COMMUNITY BOARD FEEDBACK PACKAGE

Business Name: DOLLY VARDEN

Cafe Location: 302 WEST 51 STREET, NEW YORK, NY, 10019

Application Number: 20240731010032

REVISED SITE PLAN

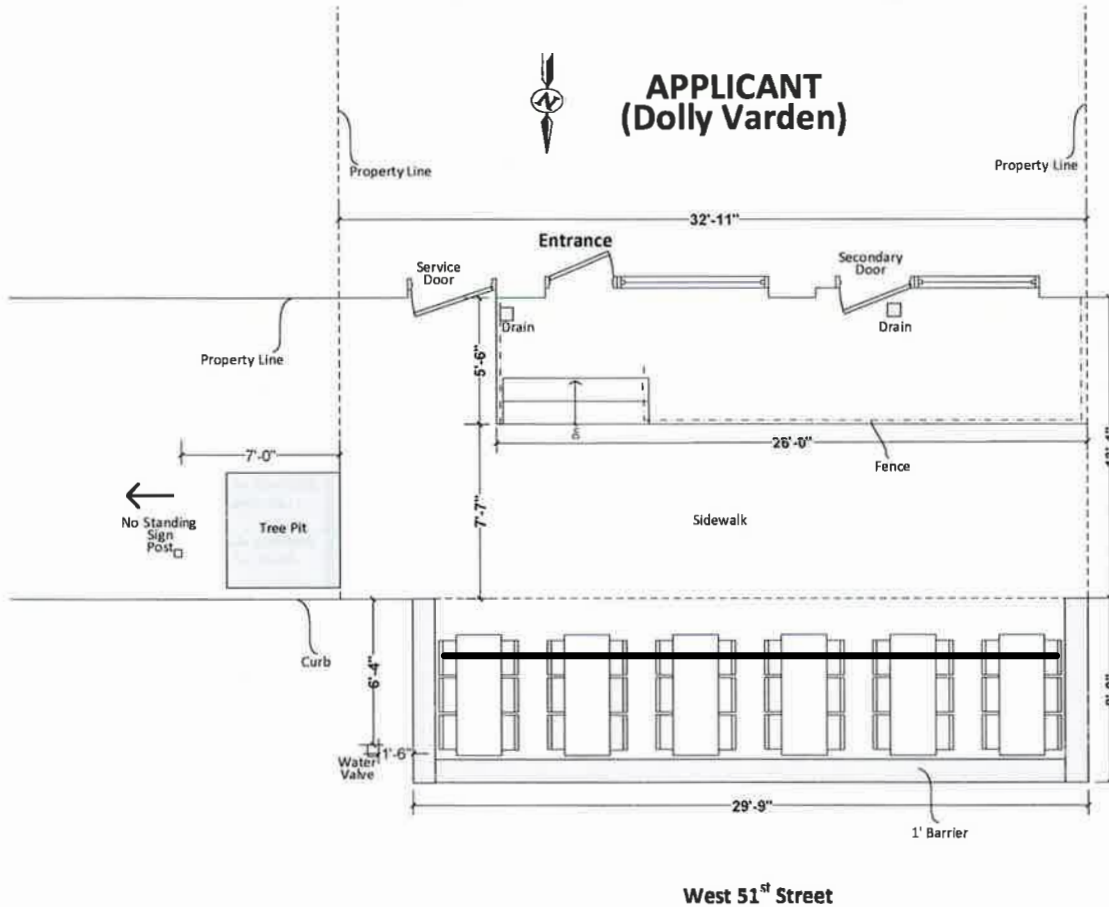
Comments related to the cafe's **physical footprint and dimensions**:
The number of tables and chairs on the proposed Site Plan (18 tables with 2 chairs each) cannot fit in the proposed footprint of the roadway cafe. Applicant has agreed to remove 6 tables with 2 chairs each from the south end of the cafe, reducing the cafe to 12 tables with 2 chairs each.

Overall recommendation for the cafe setup:
Community board recommends approval with modifications:
To fit within the proposed footprint of the roadway cafe, MCB4 requests modifications to the cafe. Applicant has agreed to these modifications and has removed 6 tables with 2 chairs each. A Revised Site Plan, reducing the cafe to 12 tables with 2 chairs each -- to which applicant has agreed -- is attached.

Suggested modifications related to the above referenced application:
Community board recommends approval with modifications:
To fit within the proposed footprint of the roadway cafe, MCB4 requests modifications to the cafe. Applicant has agreed to these modifications and has removed 6 tables with 2 chairs each. A Revised Site Plan, reducing the cafe to 12 tables with 2 chairs each -- to which applicant has agreed -- is attached.
